ENVIRONMENTAL COMMITTEE MEETING

January 7, 2026

Subject: Review of redevelopment plans for 150 Thompson Ave. E.

Review submitted plans for the redevelopment of the 424 Butler Avenue East property.

DRAWING N°
C-1

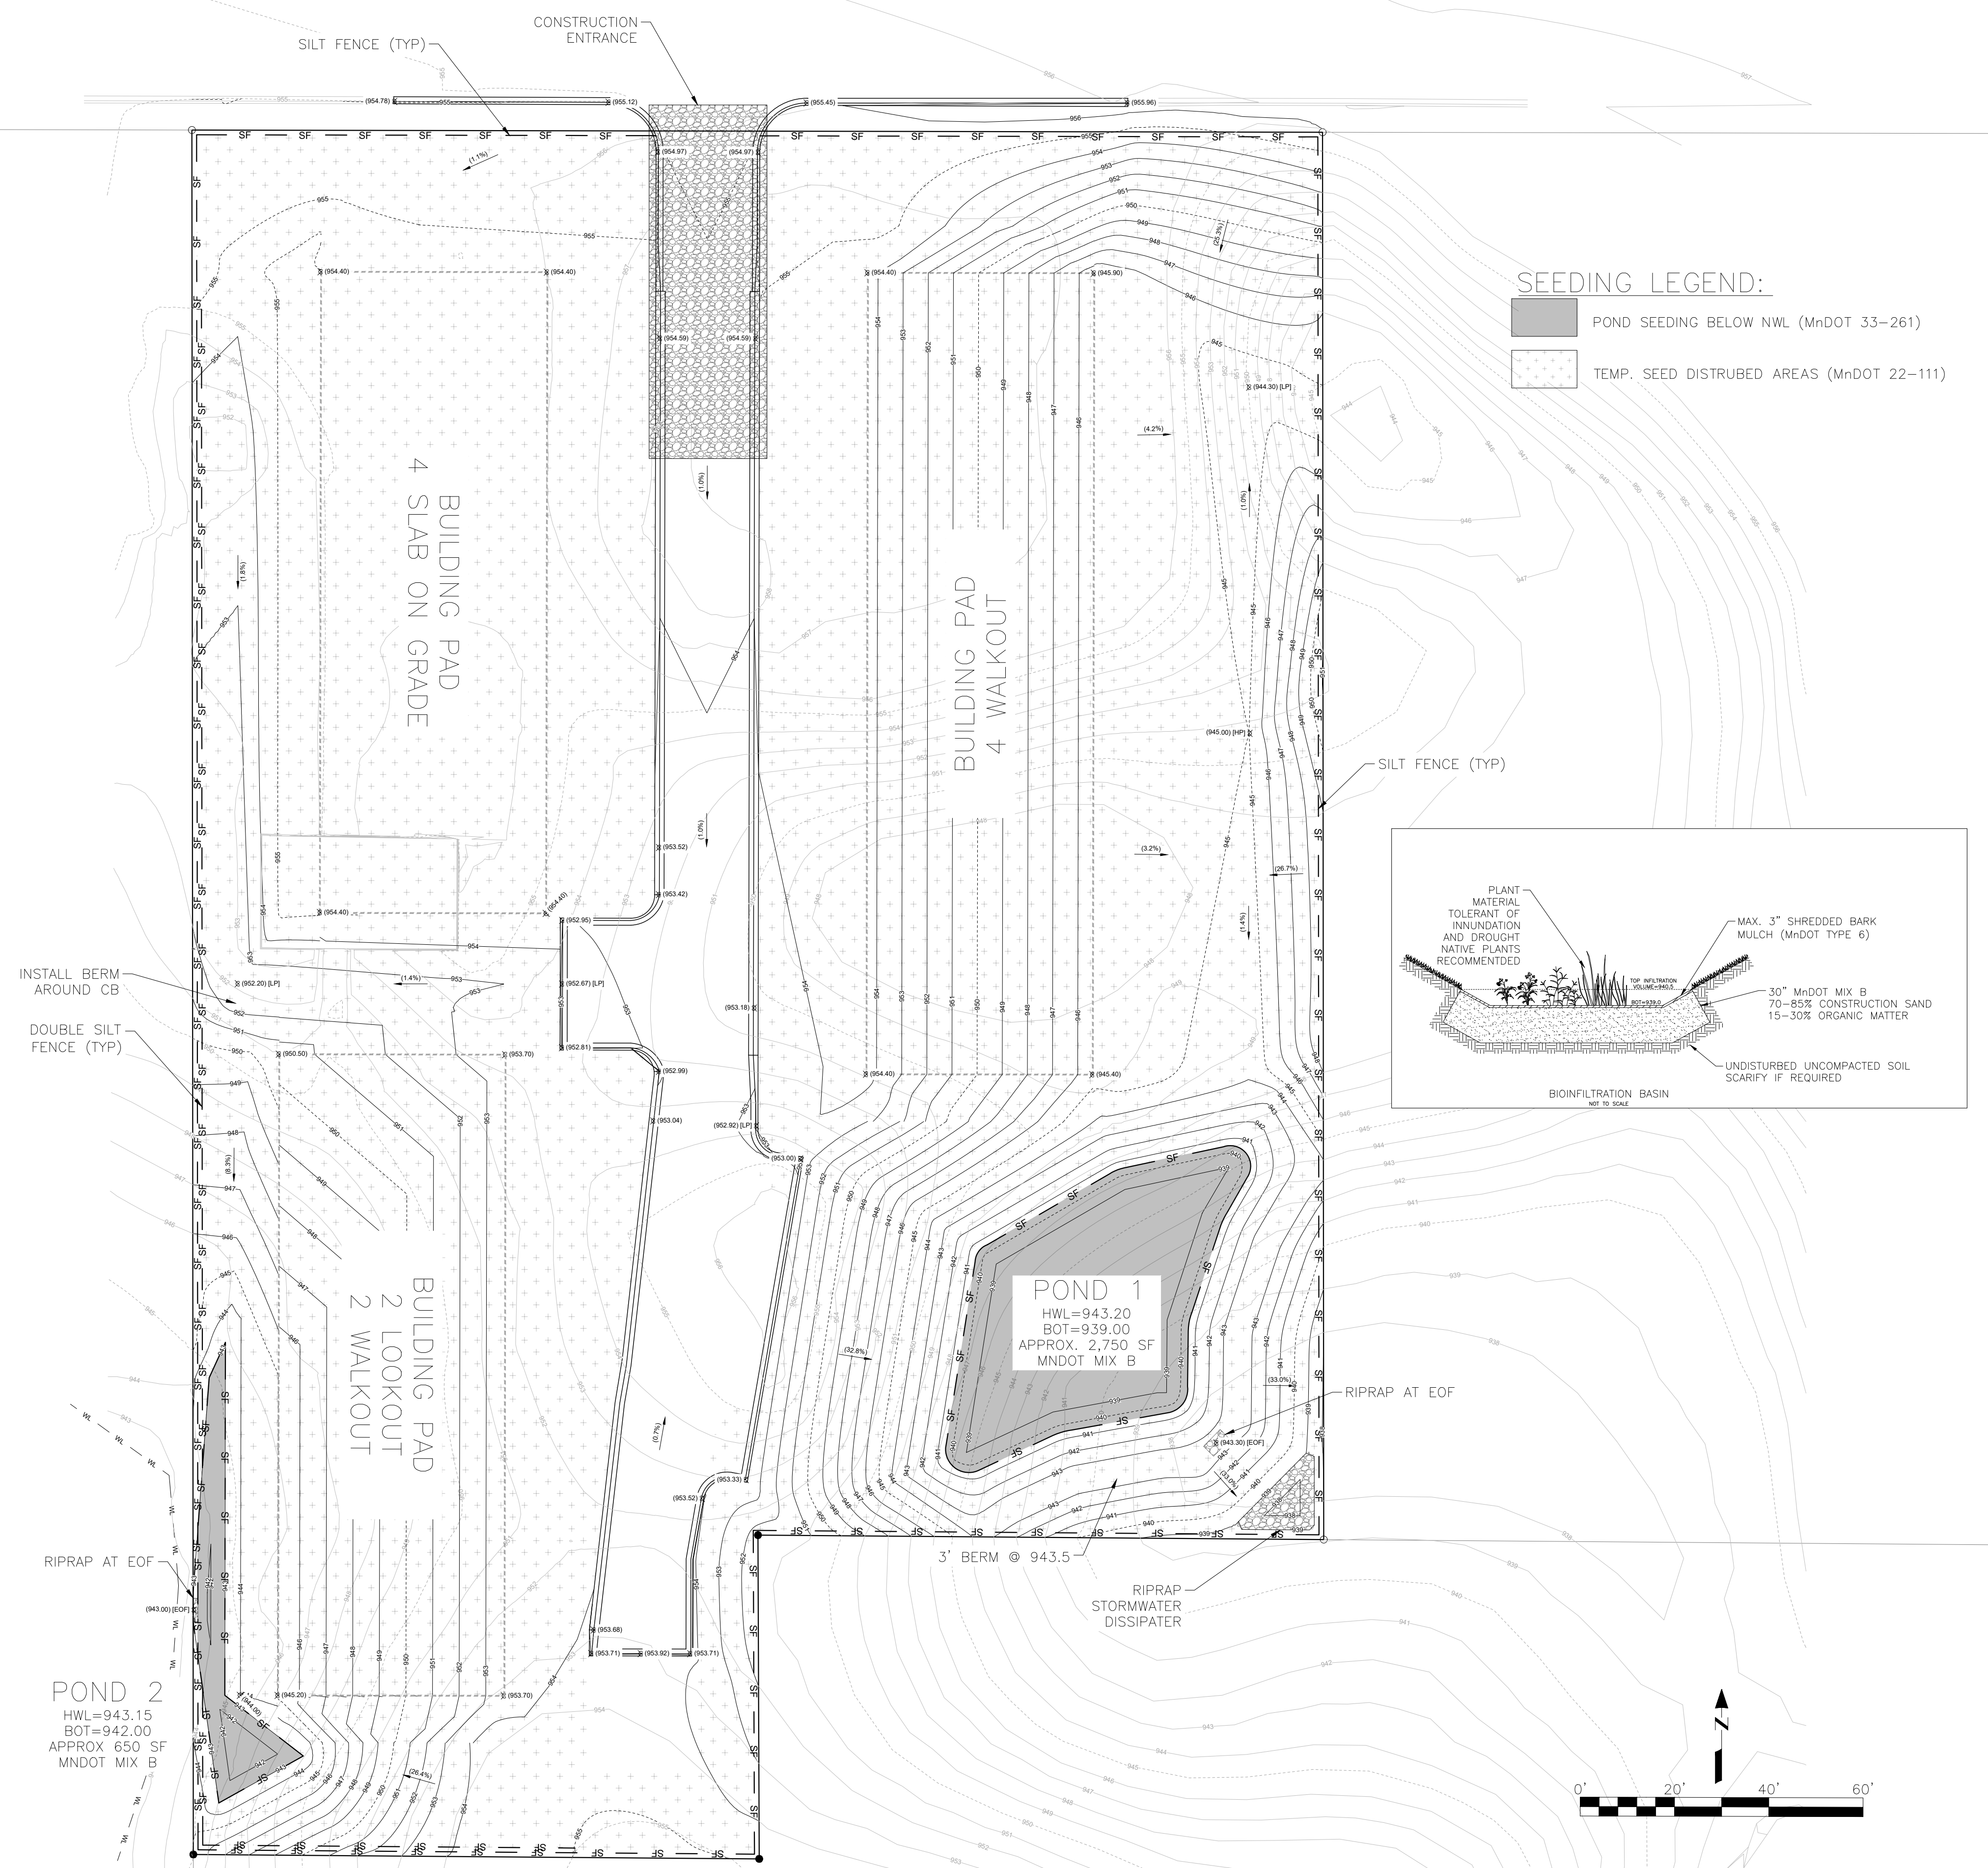
The submitted plans detail the removal of all trees on site, as the site will need to be re-graded to ensure sufficient drainage. Page C-1 of the submitted plans shows further details on the type and status of the existing trees, but a summary of the removals is included below.

When trees are removed as a part of the site plan process, at least 30% of the quality trees (at least 2.5 cal. in.) must be replaced. Based on the submitted plans, the minimum replacement requirement calculates to 359 inches (roughly 144 trees if measuring at 2.5”).

DRAWING Nº
C-3

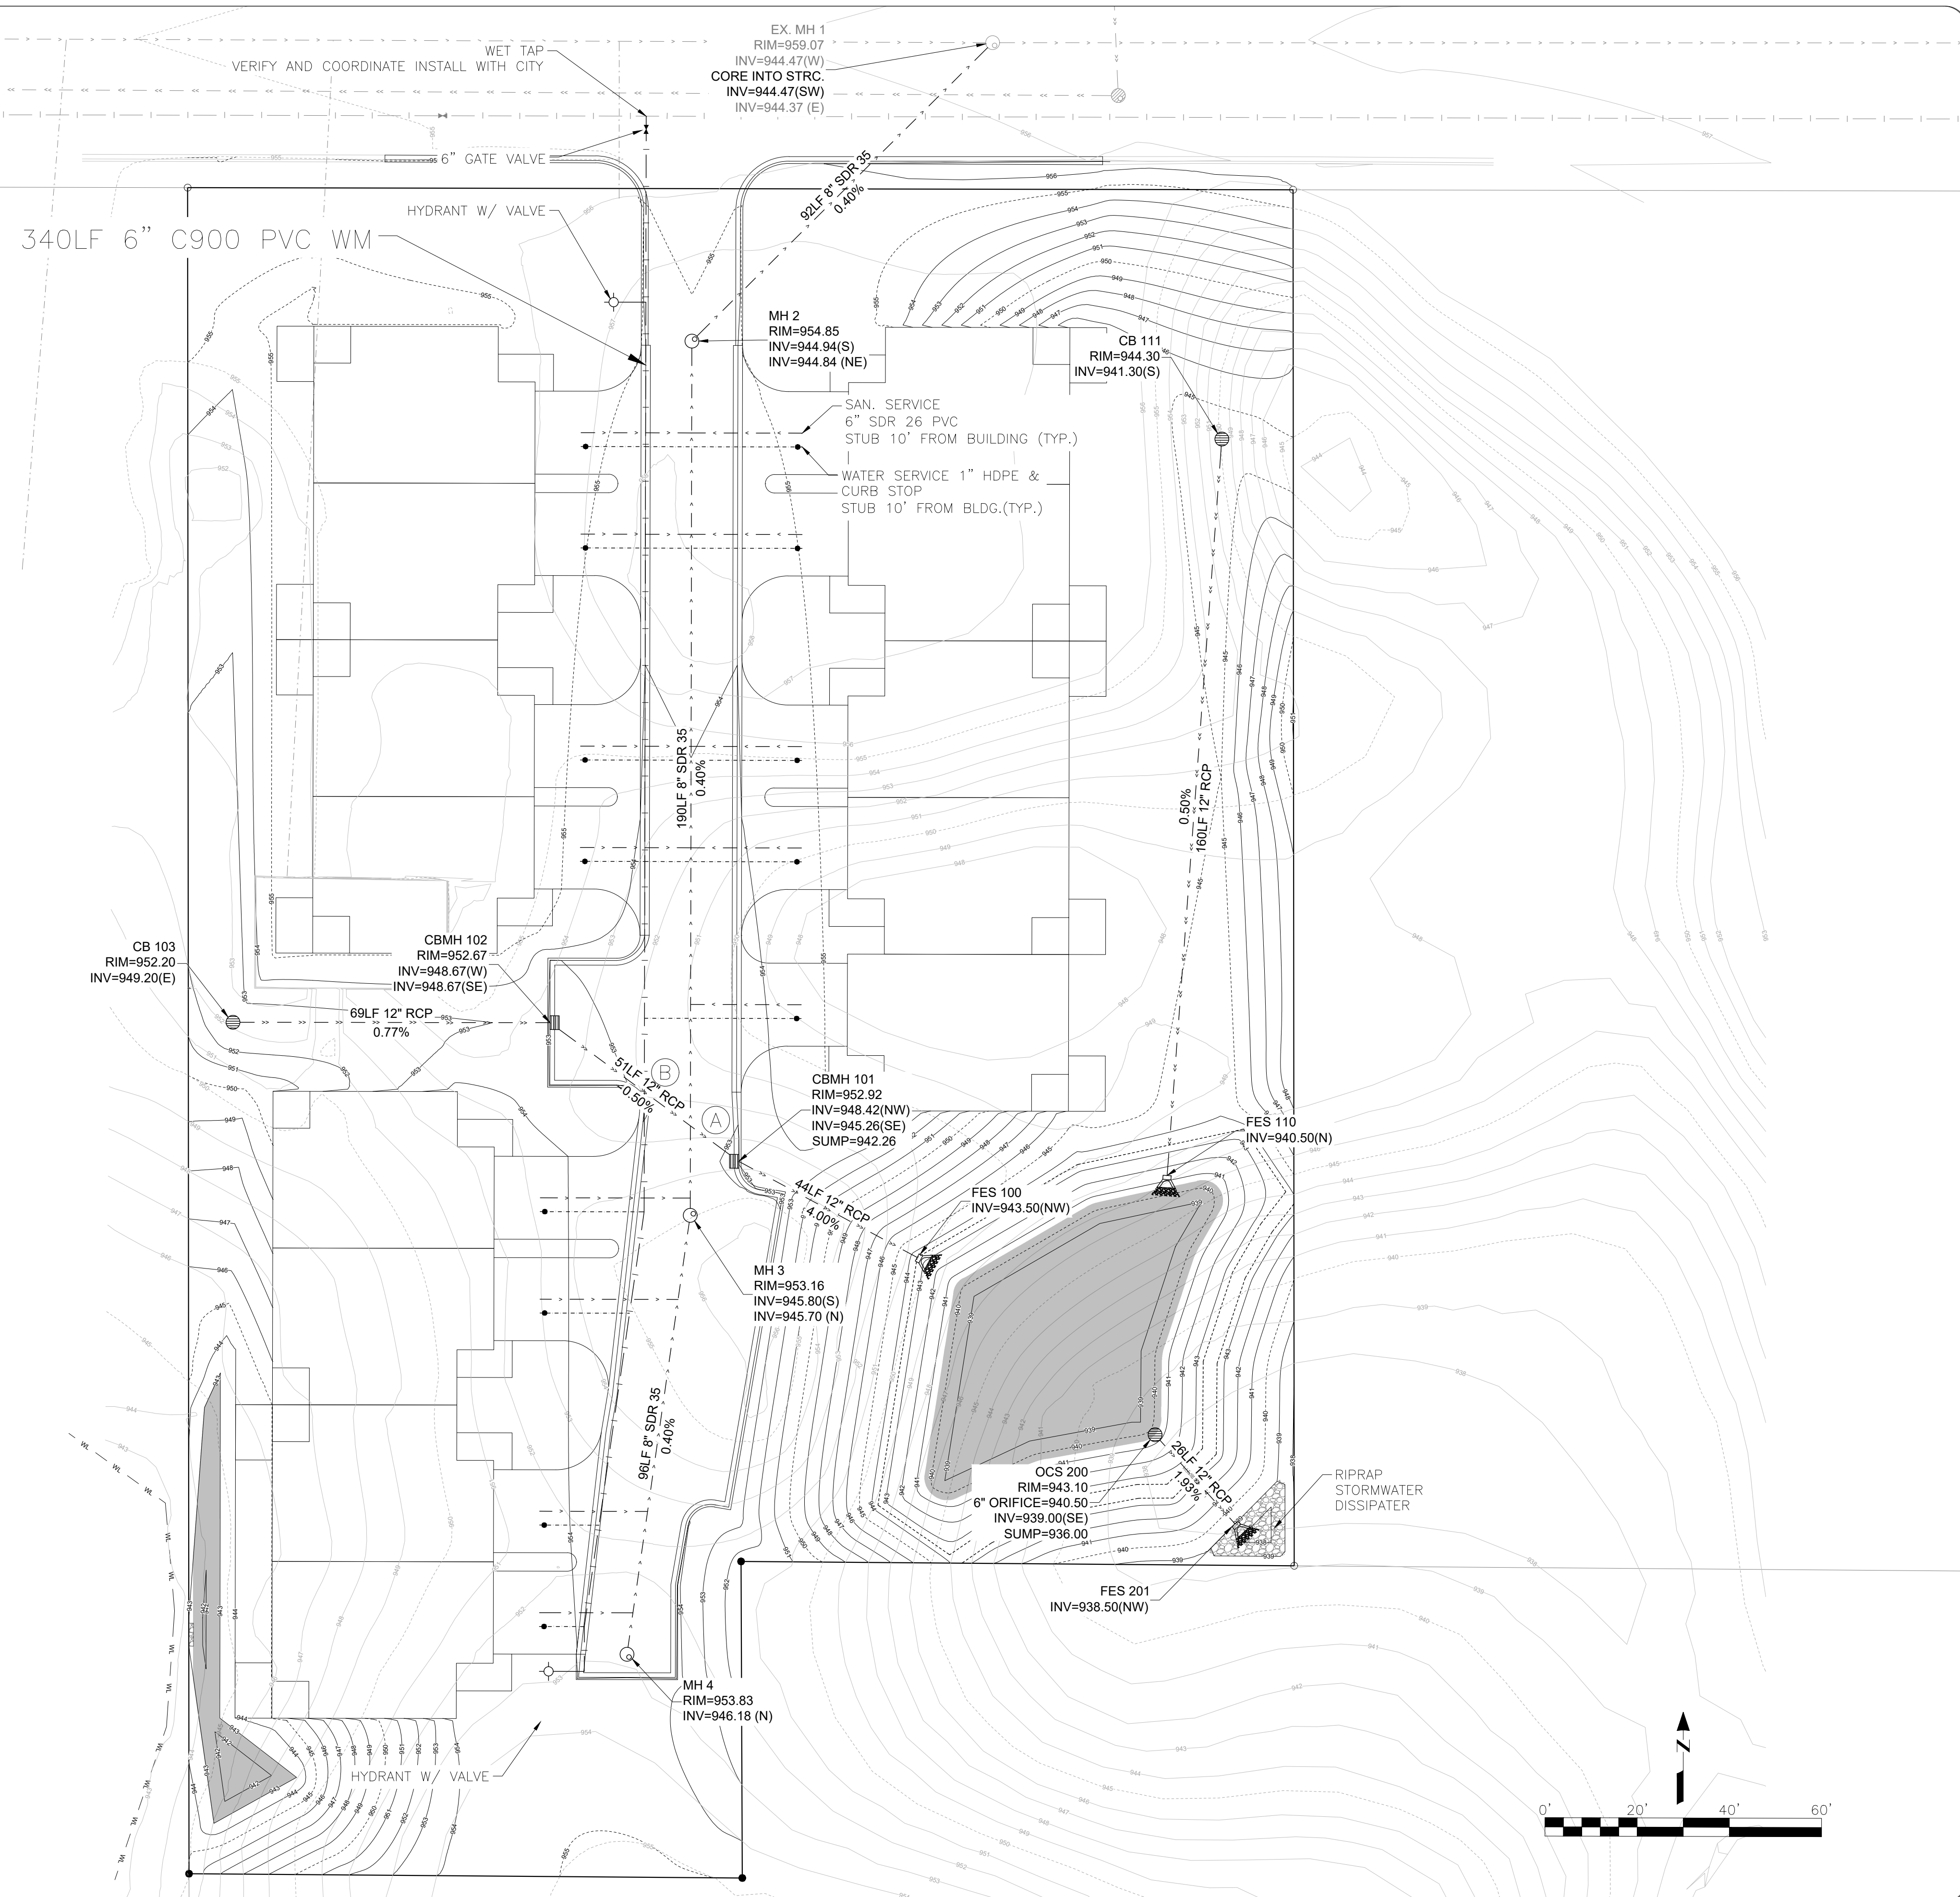
The majority of the stormwater from the site will be filtered through the biofiltration basin in the southeast section of the site, with a small portion also draining to the southwest. Final site grading can be seen on page C-3 of the included plans.
